TECHNICAL BULLETIN	
	March 2004 TB 2150
Mfg:	GM
Model:	COBALT
Liter:	2.2L
V I N:	F
Year:	00-08

Cylinder Head Bolt Caution On
2001-02 GM 2.2L VIN F Engines

Figure 1. Cylinder Head Bolt Torque Sequence.

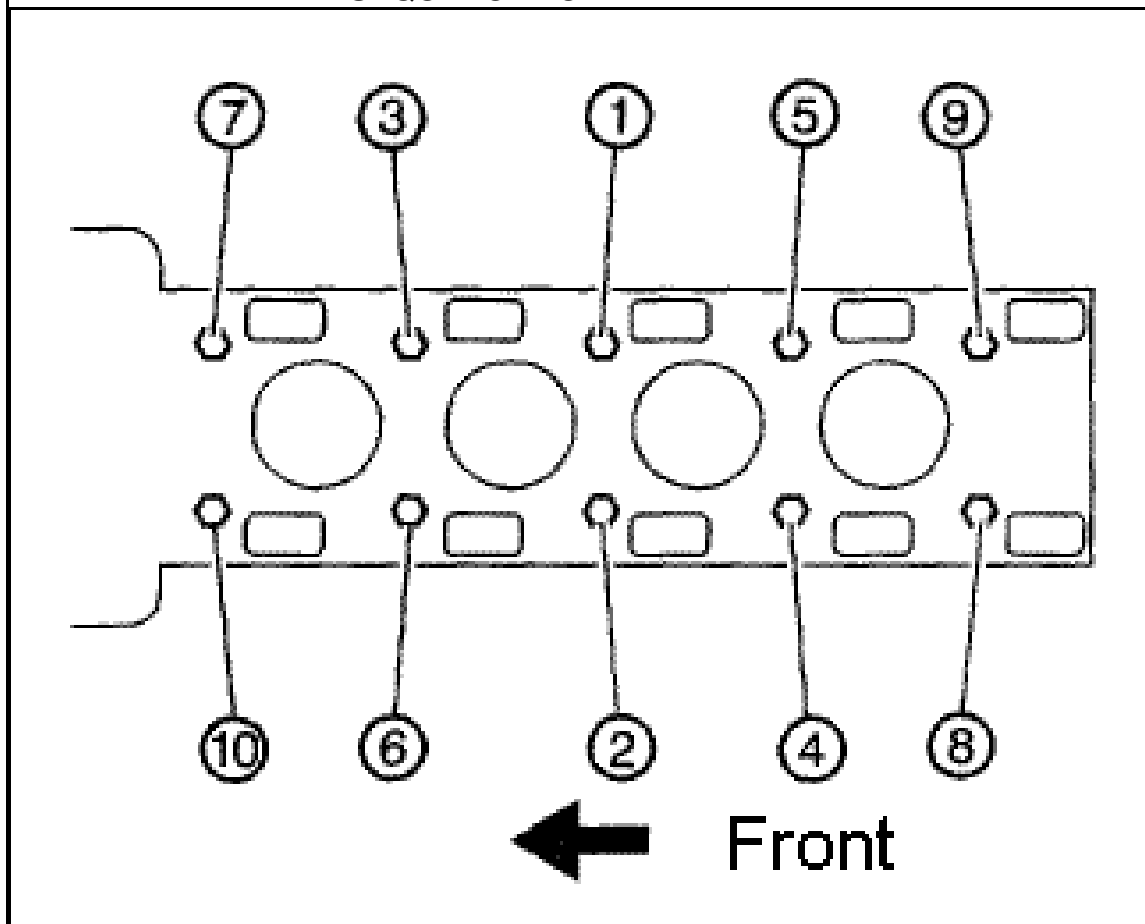
The AERA Technical Committee offers the following information regarding a cylinder head bolt caution on 2001-02 GM 2.2LVIN F engines. Apparently previously published Saturn service manuals have the incorrect torque listed.

If the published torque is used, cylinder head bolt breakage may occur. Previously published head torque showed an additional 185° added for the last ending torque procedure. The correct torque for this engine should be 22 ft/lbs + 155°. Any time that the cylinder head is taken off of this engine, cylinder head bolts must be replaced. Follow the torque sequence provided below in Figure 1.

22 ft/lbs + 155°
